DEPARTMENT OF ENERGY**Federal Energy Regulatory Commission****18 CFR Part 40**

[Docket Nos. RM12-6-000 and RM12-7-000]

Revisions to Electric Reliability Organization Definition of Bulk Electric System and Rules of Procedure**AGENCY:** Federal Energy Regulatory Commission, DOE.**ACTION:** Notice of proposed rulemaking.

Figure 1

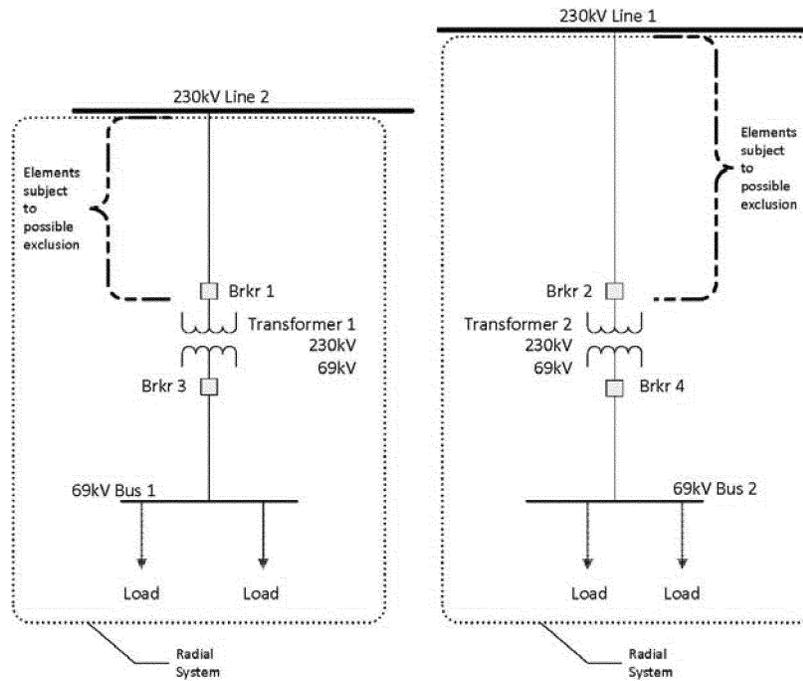
79. Figure 1 below depicts facilities configurations in which all of the 230 kV and 69 kV transmission elements emanate from a single point of connection of 100 kV or higher. The Commission seeks comment on whether each of the radial systems shown in figure 1, the 230 kV elements above each transformer to the point of connection to each 230 kV line, respectively, are excluded from the bulk electric system pursuant to exclusion E1.

Figure 2

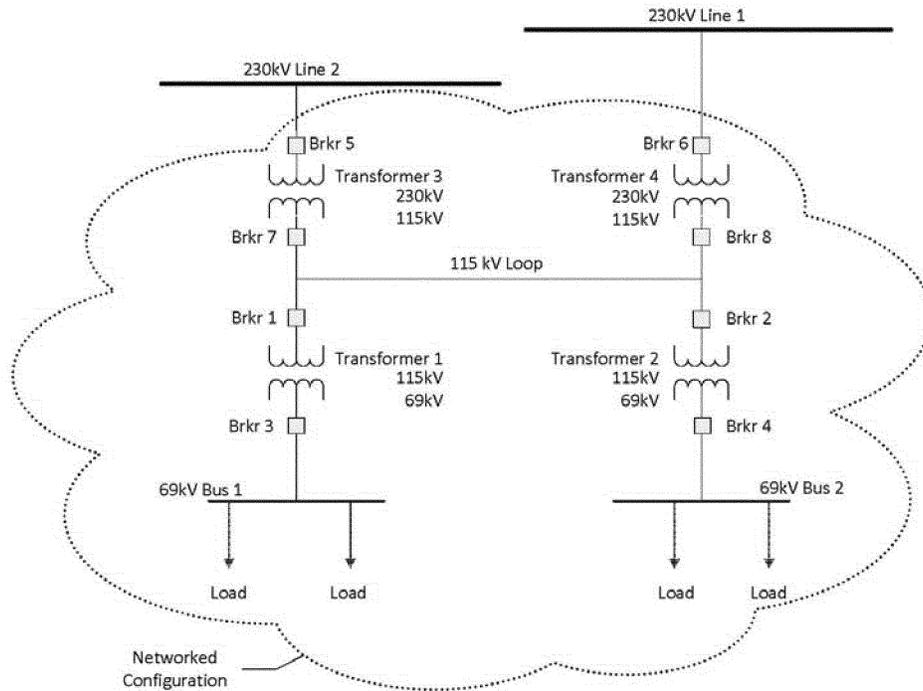
80. Another scenario shown in figure 2 below depicts a configuration containing a 115 kV loop, with the configuration emanating from two points of connection of 100 kV or higher. We seek comment whether, in

shown in figure 2 more appropriately analyzed pursuant to the "local network" exclusion E3 and, if so, what if any elements operated at or above 100 kV would be excluded pursuant to exclusion E3?

Figure 3

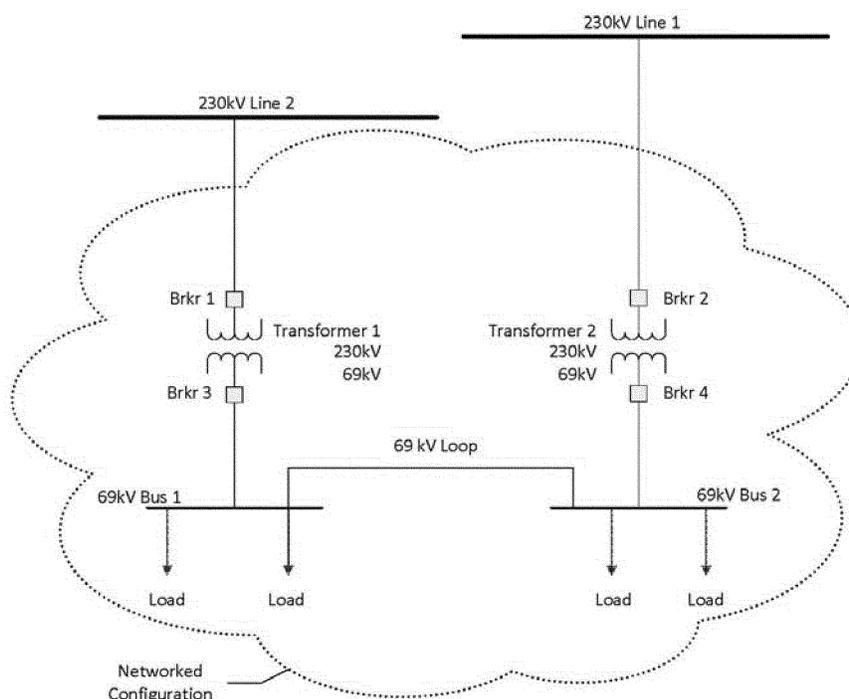
configuration remains contiguous through elements that are operated below 100 kV. For example, figure 3 below depicts a configuration with two points of connection of 100 kV or higher that are contiguous through a 69 kV loop. We seek comment on how to evaluate the configuration in figure 3 vis-à-vis the radial system definition and whether it is appropriate to examine the elements below 100 kV to

determine if the configuration meets the exclusion E1 definition for radial systems. In other words, does figure 3 depict a system emanating from two points of connection at 230 kV and, therefore, the 230 kV elements above the transformers to the points of connection to the two 230 kV lines would not be eligible for the exclusion E1 notwithstanding the connection below 100 kV?

Figure 4
69 kV Networked Configuration with Normally Open Switch

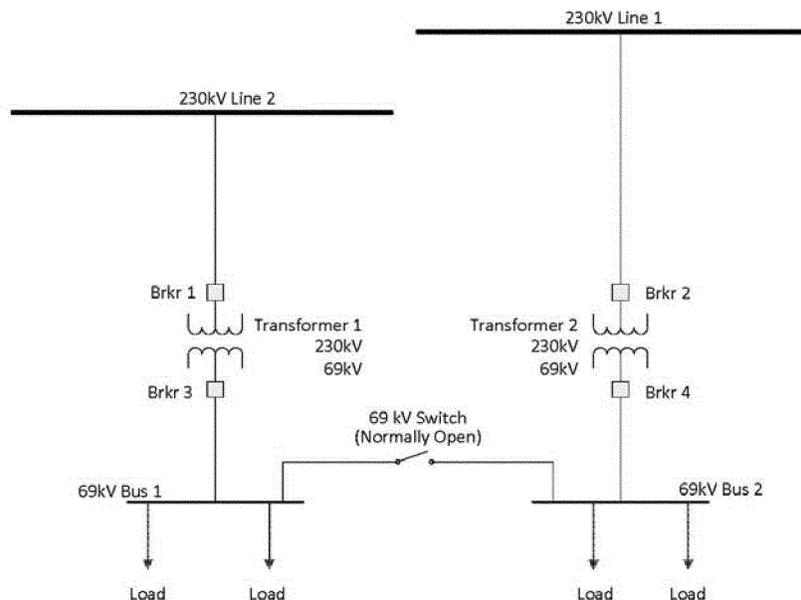
86. Figure 4 below illustrates a configuration with a normally open switch.

NERC states that “[t]he concept that two sets of radial facilities that are normally unconnected to each other should be subject to * * * applicable Reliability Standards during the limited time periods when they are connected by the closing of the normally open switch in the maintenance-related or outage-related circumstances described above would be fundamentally impractical and unworkable (from both the entity’s perspective and the ERO’s perspective), and would misapprehend this very common, reliability-driven facilities configuration.”¹⁰⁴

87. NERC states that “a normally open switch” will be identified in documents such as prints or one-line diagrams and that “[t]he concept and usage of the ‘normally open switch’ in such configuration is well understood in the electric utility industry.”¹⁰⁵ We seek comment on NERC’s characterization and whether the phrase “normally open” is subject to interpretation or misunderstanding, or whether a “normally open” configuration is potentially difficult to oversee. Further, we seek comment on the need of transmission operators or other functional entities to study the system impacts of the closing of a “normally open” switch, or to take other steps to ensure awareness of the impacts of the loop that is created by the closing of the

Figure 5

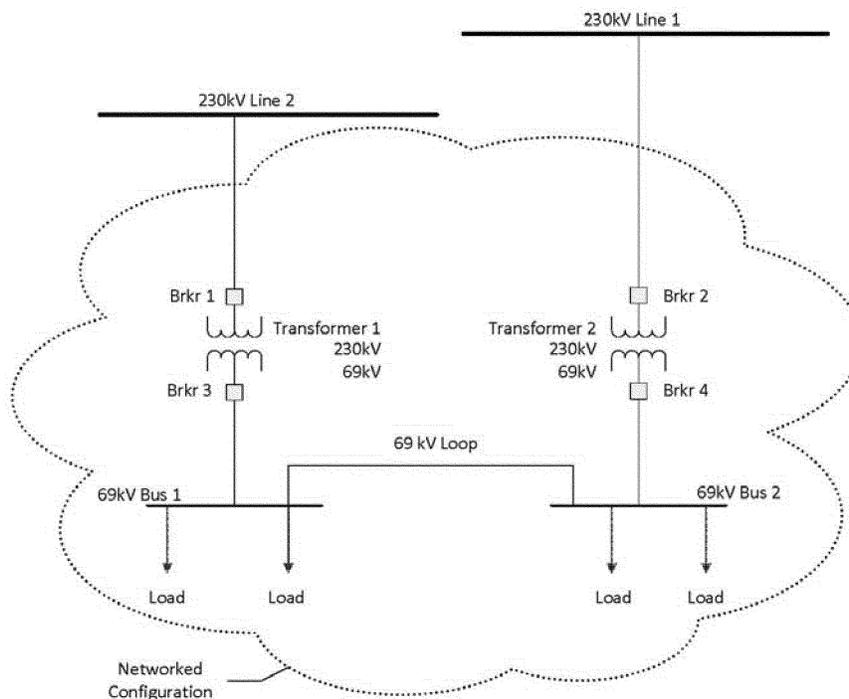
95. As stated above, exclusion E3 defines local networks as “[a] group of contiguous transmission Elements operated at or above 100 kV but less than 300 kV that distribute power to Load rather than transfer bulk-power across the interconnected system.” While the local network exclusion applies to contiguous transmission elements operating at a minimum of 100 kV, it is unclear how the exclusion applies to a looped lower voltage system. For example, figure 5 depicts a 69 kV looped system emanating from two points of connection at 100 kV or higher.

The configuration in figure 5 depicts a group of elements that are contiguous through a 69 kV loop. We seek comment whether the configuration in figure 5
